Coolant Pipe, Radiator (Lower)
 VAH
 D11H, D13H

FSB 261-036, Coolant Pipe, Radiator (Lower)

(January 2013)

W2076923

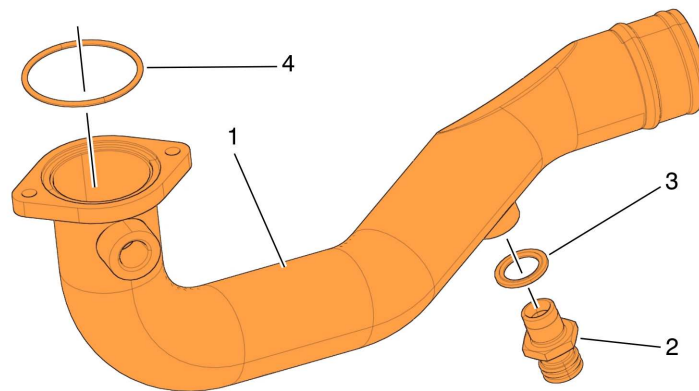
Some VOLVO VAH trucks built with lower coolant pipe 21783978 or 21585759 may experience contact between the engine coolant service nipple and the steer axle under heavy load and braking conditions. Insufficient clearance between the engine coolant service nipple and the steer axle may cause a minor coolant leak at the service nipple. A new engine coolant pipe has been designed with the service nipple relocated for increased clearance. If this condition is encountered, install new pipe (22013490), service nipple (1676622), o-ring (975675), and gasket (979099).

W2076929

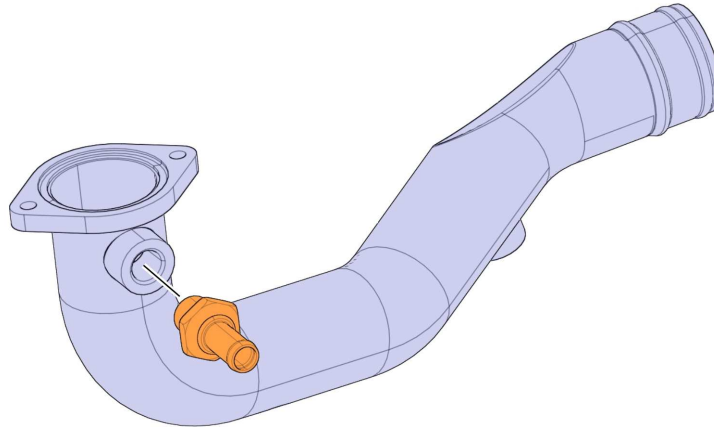
11 Transfer the power steering cooler line nipple from the existing lower coolant pipe to new pipe (22013490). Tighten cooler line nipple to 34 ± 4 Nm (25 ± 3 ft-lb).

W2076930

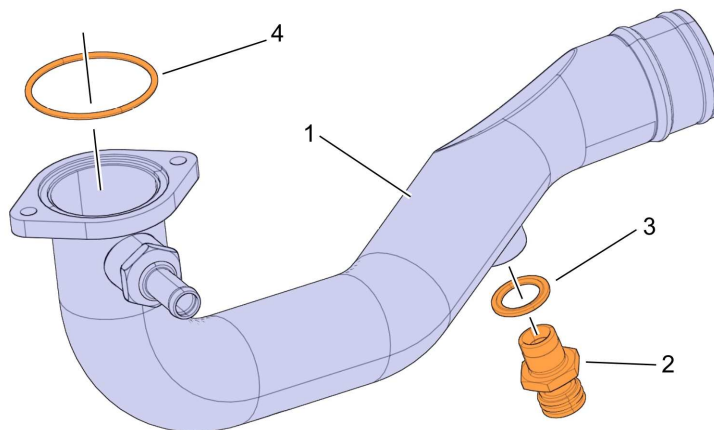
12 Install replacement o-ring (975675), service nipple (1676622), and gasket (979099) on new lower coolant pipe. Tighten service nipple to 34 ± 4 Nm (25 ± 3 ft-lb).
